HOPE CREEK GENERATING STATION  
DOCKET NO. 50-354  
FSAR COMMITMENT STATUS THROUGH AUGUST 1984

ATTACHMENT I  
HOPE CREEK GENERATING STATION  
FSAR COMMITMENT STATUS THROUGH AUGUST 1984

QUESTION 220.21 (SECTION 3.7.2)

FIGURE 220.21-49  
 RESPONSE SPECTRA COMPARISON,  
 INTAKE STRUCTURE AT ELEV. 93'-0",  
 VERTICAL, SSE, 2% DAMPING

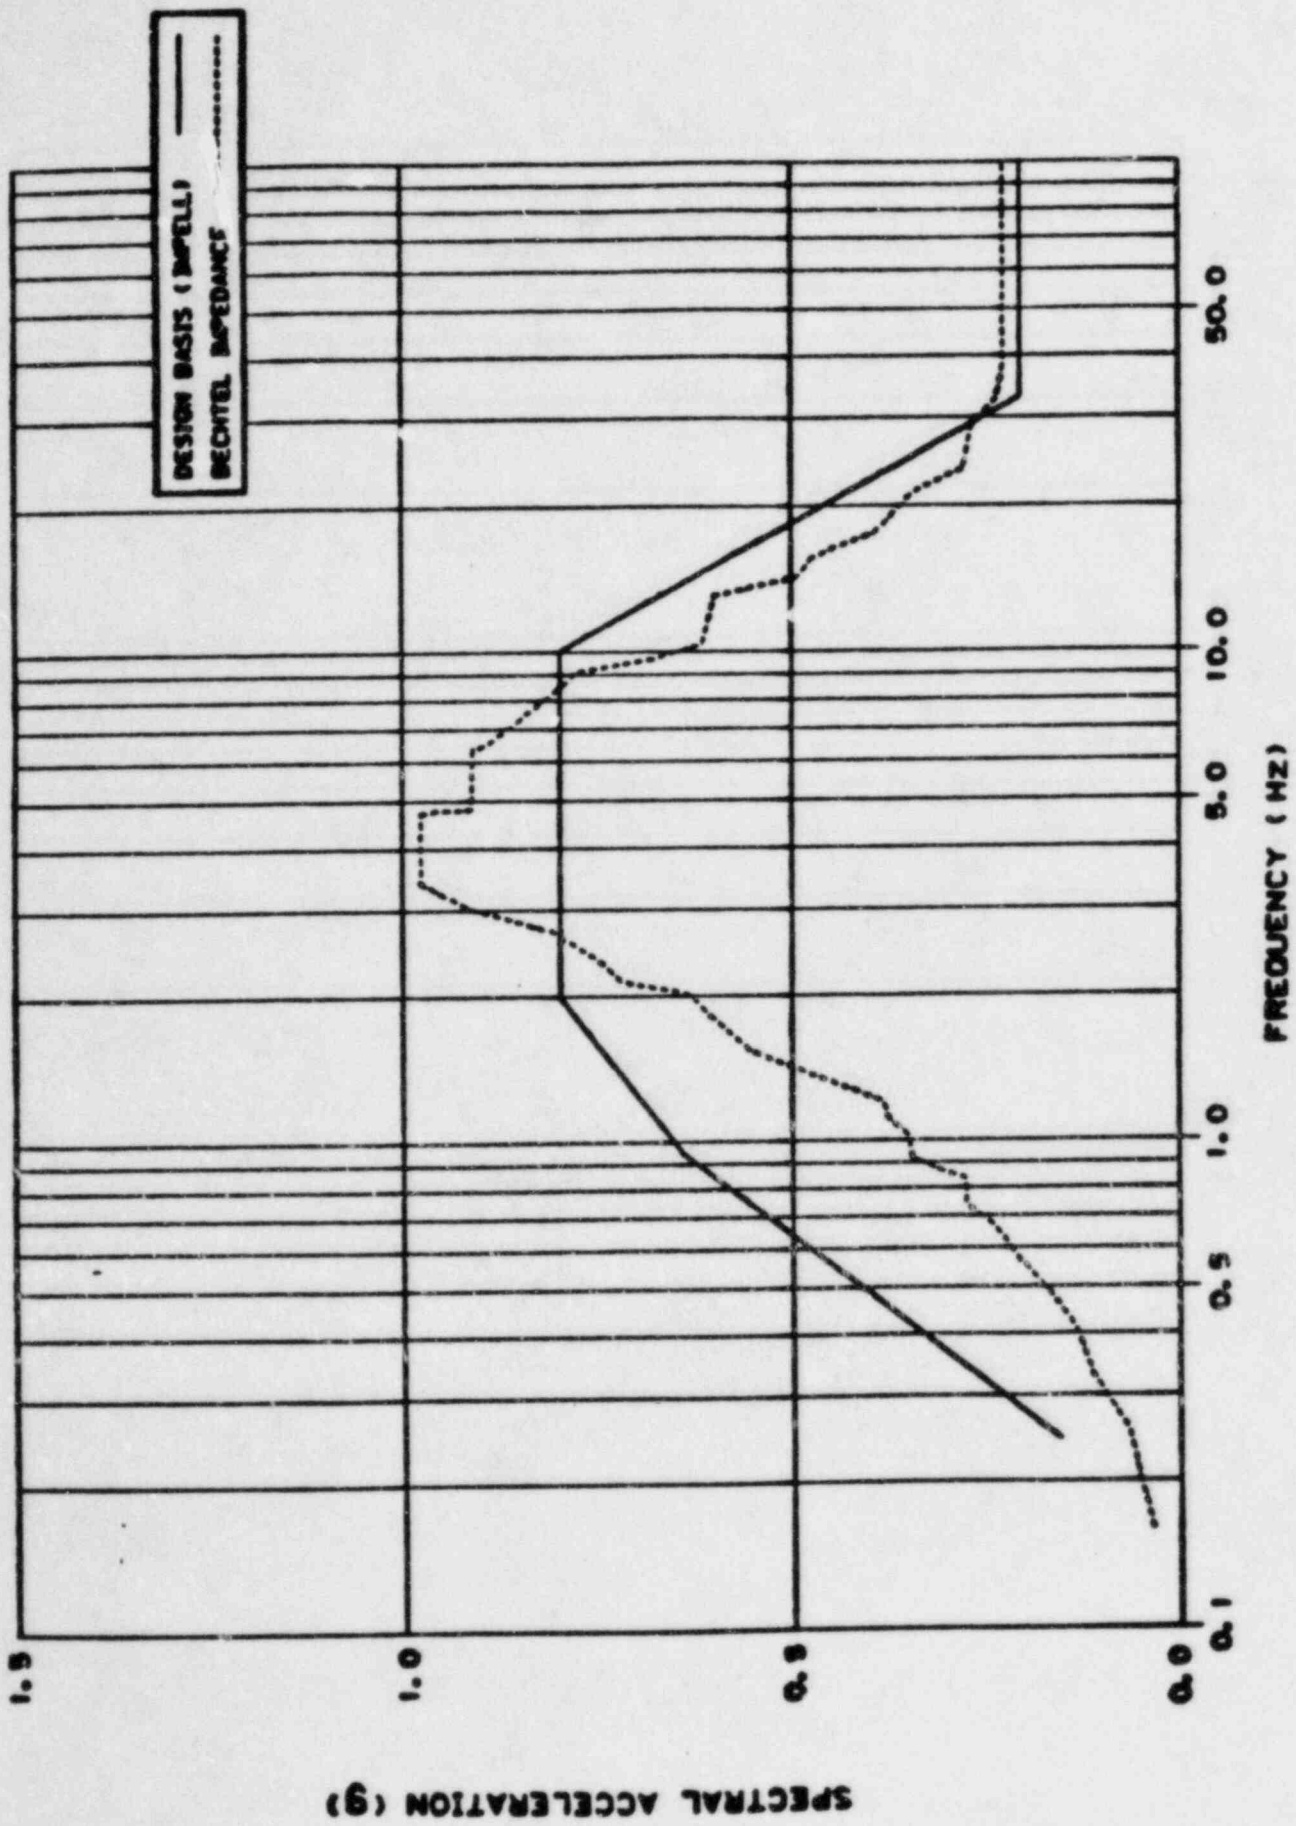
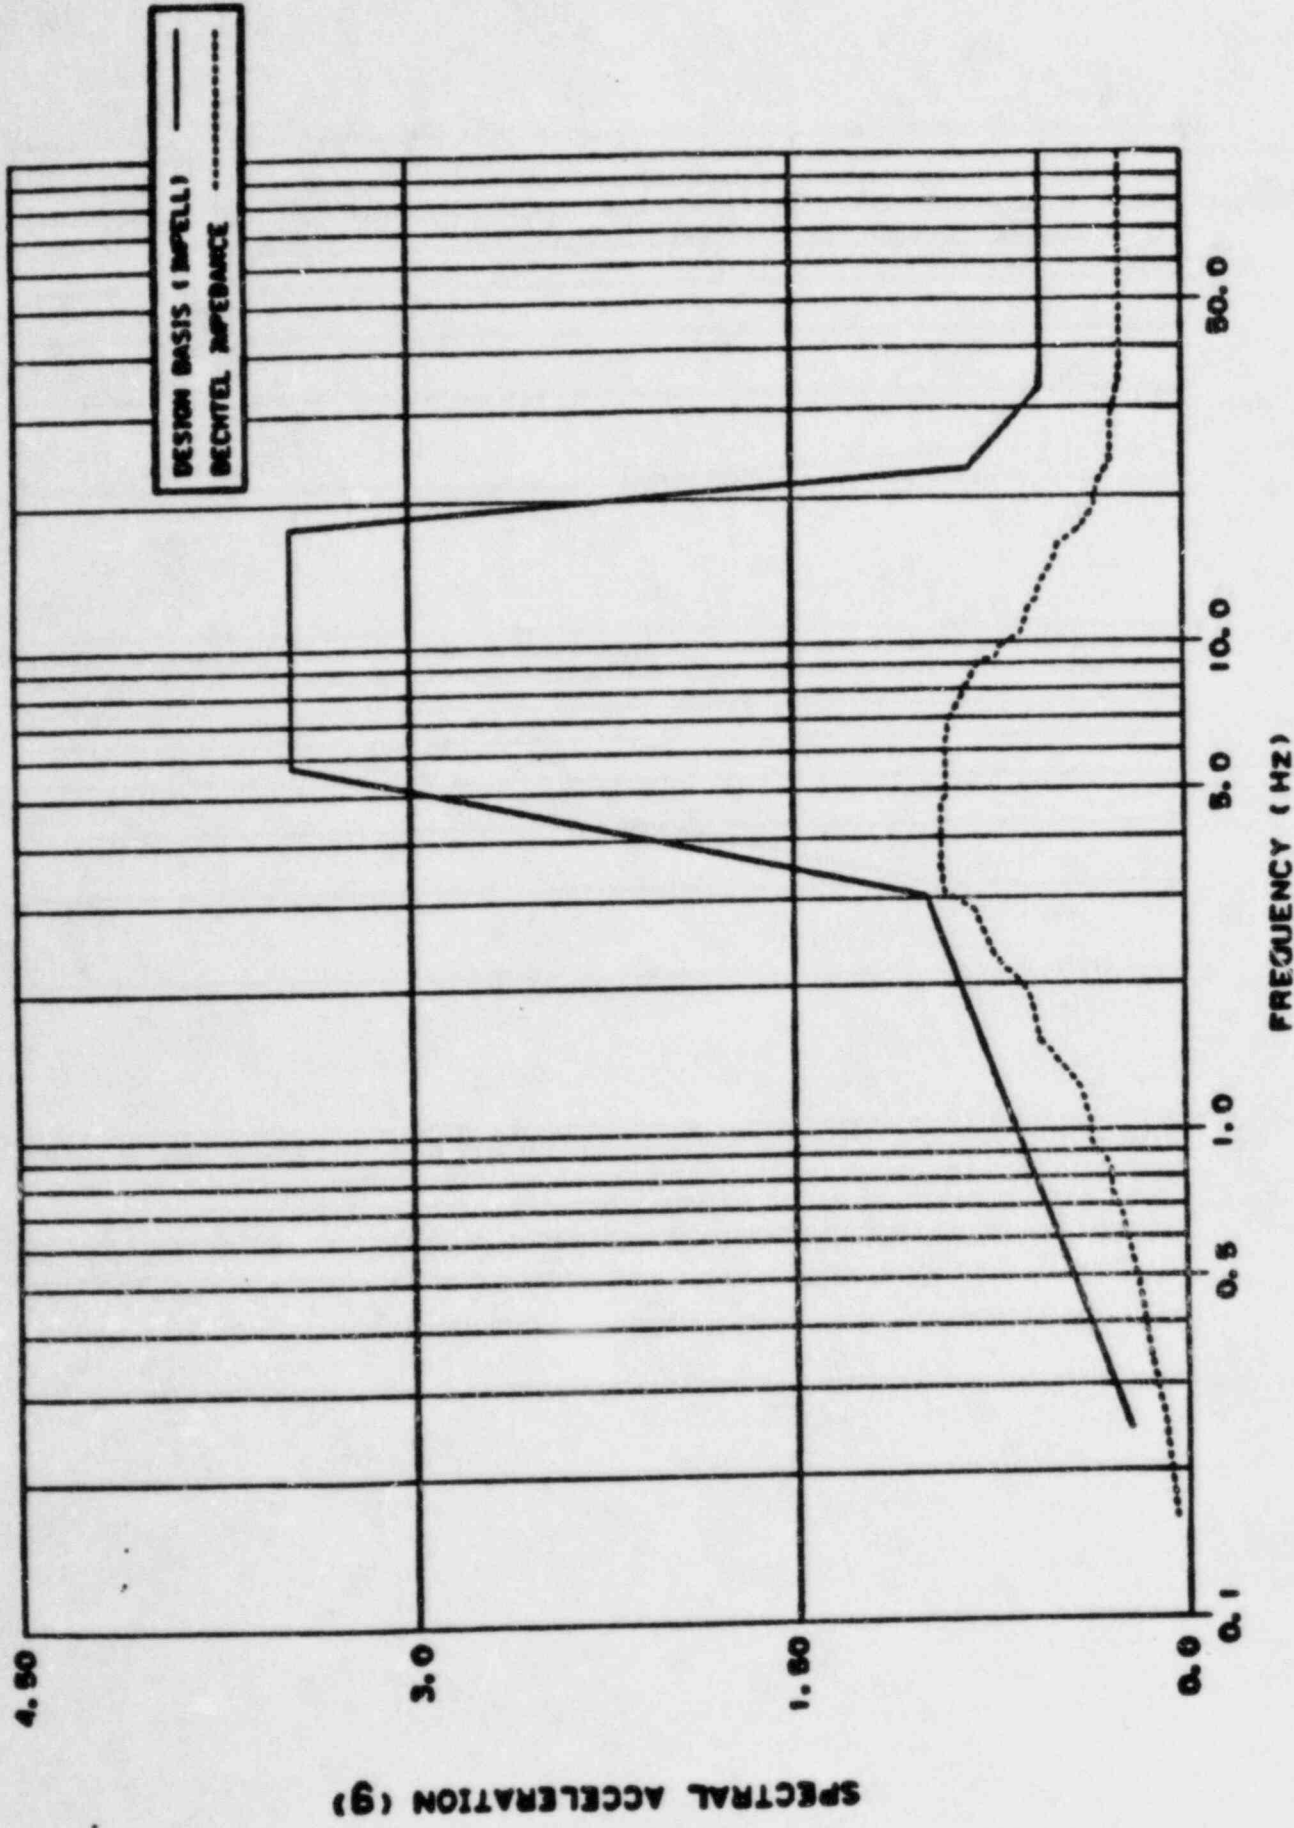
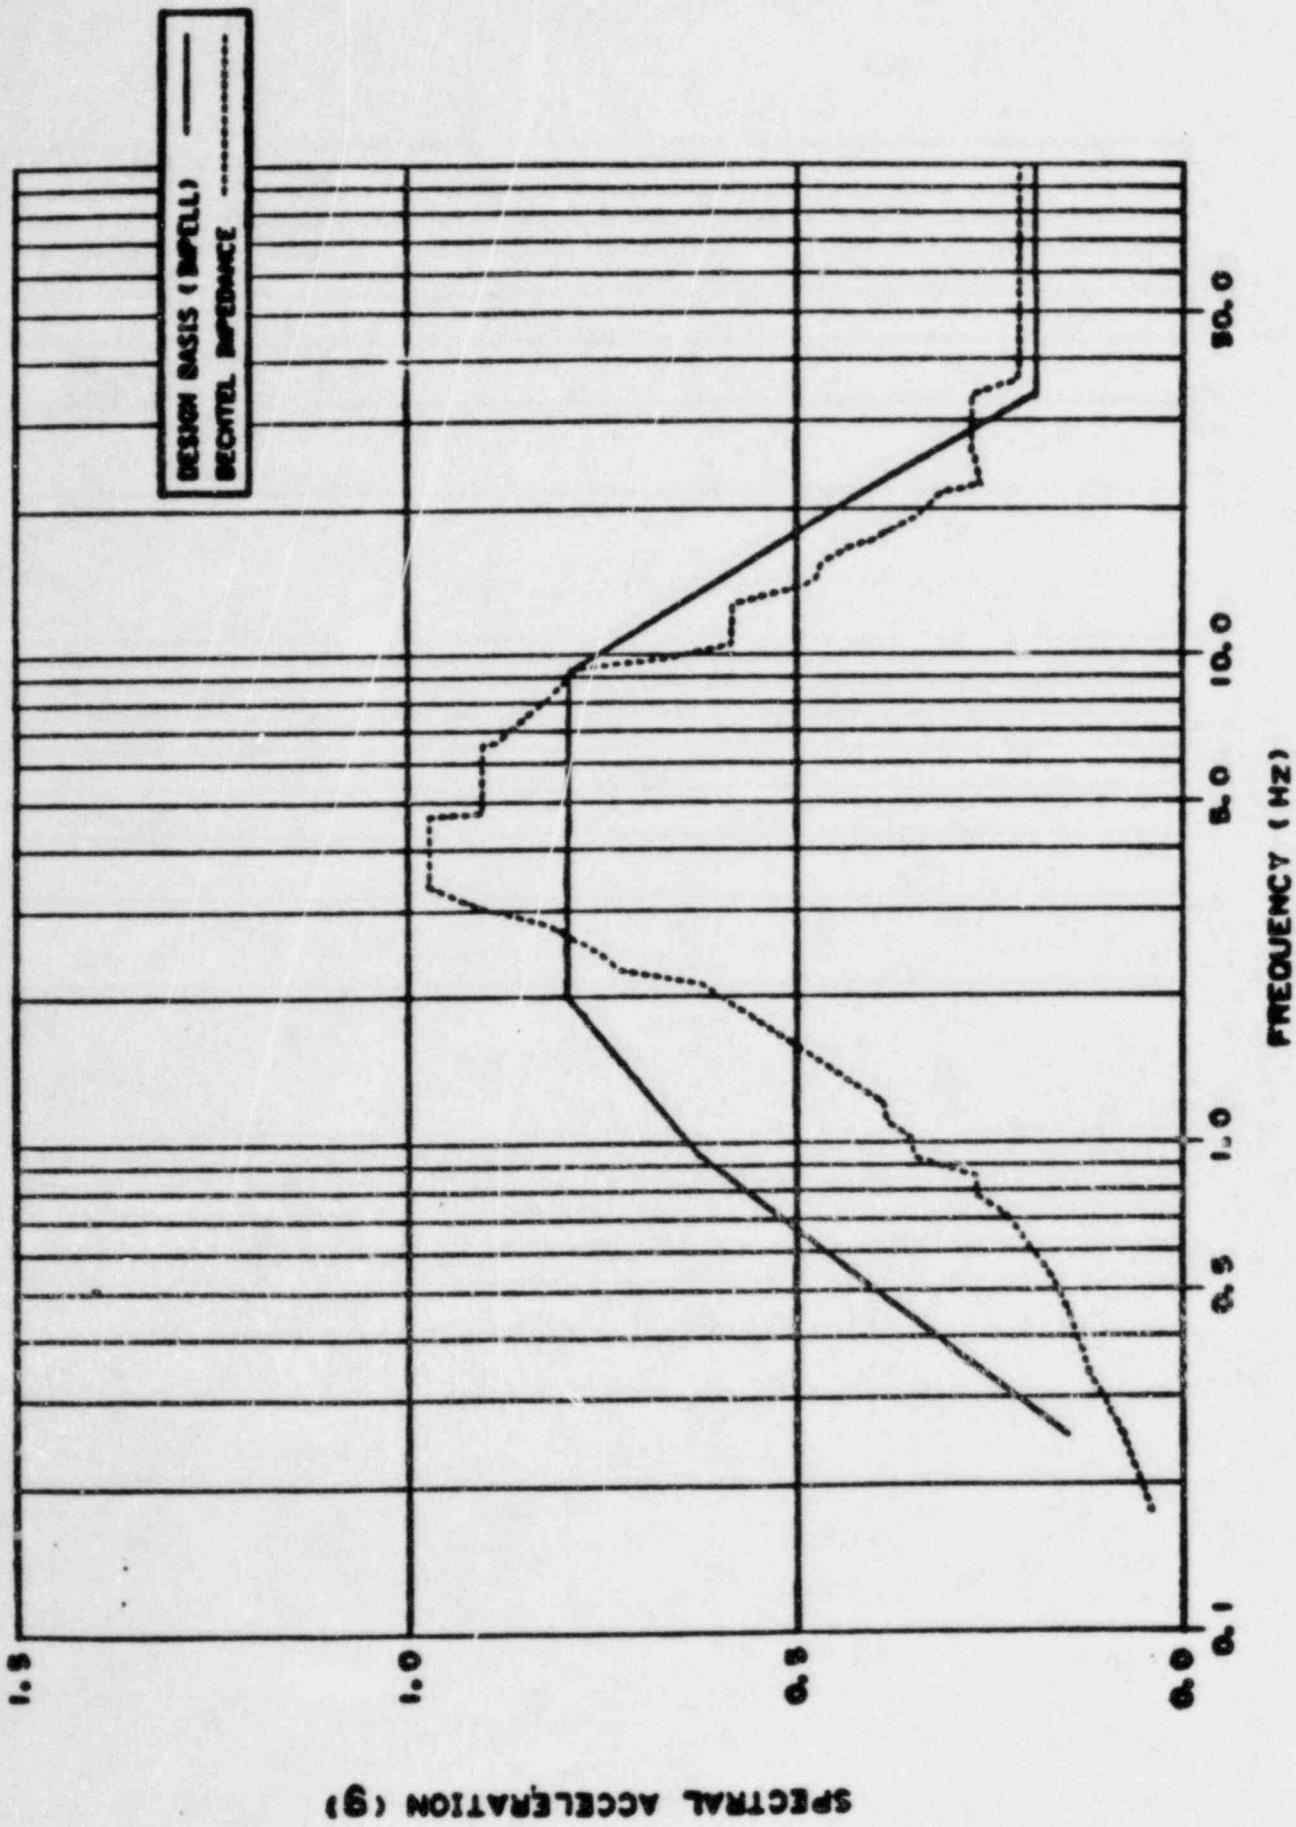
The Hope Creek soil-structure interaction analysis is performed by applying a specified earthquake input motion at the base of the finite-element model. The base level input motion is generated through a deconvolution analysis. The applicable SRP criteria for soil-structure interaction analysis require that both the half-space and finite-element approaches should be considered. (For details refer to SRP 3.7.2-11.4). Public Service should perform necessary analyses to demonstrate conformance to the criteria.

Figures 220.21-1 through 220.21-54 show a comparison of the 2 percent damping response spectra obtained from the design basis finite element and the impedance analyses for the reactor building, auxiliary building and the service water intake structure (SWIS).

¶ For the reactor and auxiliary buildings, the peak spectral accelerations obtained from the impedance analysis are generally lower than those obtained from the design basis analysis. However, the impedance analysis response spectra are not completely enveloped by those obtained from the design basis analysis, especially in the frequency range from 1.0 to 3.5 Hz. Also, there are some local exceedances in the higher frequency range, as shown in Figures 220.21-1 through 220.21-36. ¶ For the SWIS (Figures 220.21-37 through 220.21-54), the impedance analysis response spectra are generally enveloped by those obtained from the design basis analysis at elevation 114.0 feet. For other elevations, the impedance analysis spectral accelerations exceed the design basis spectral accelerations in some frequency ranges. These ranges vary approximately between 1.5 and 10.0 Hz.

forces and moments obtained from the impedance analysis exceeded the design basis values at various locations within these buildings. The auxiliary building seismic shear forces and moments obtained from the impedance analysis are less than the design basis shears and moments.

Since the impedance analysis results are not completely enveloped by the design basis finite element analysis results, sampling studies are conducted to confirm the adequacy of the plant design. These sampling studies include an evaluation of the following items:

In all cases, the items reviewed during these sampling studies can accommodate the loads resulting from the impedance analysis. Therefore, the impedance analysis results have no impact on the plant design.
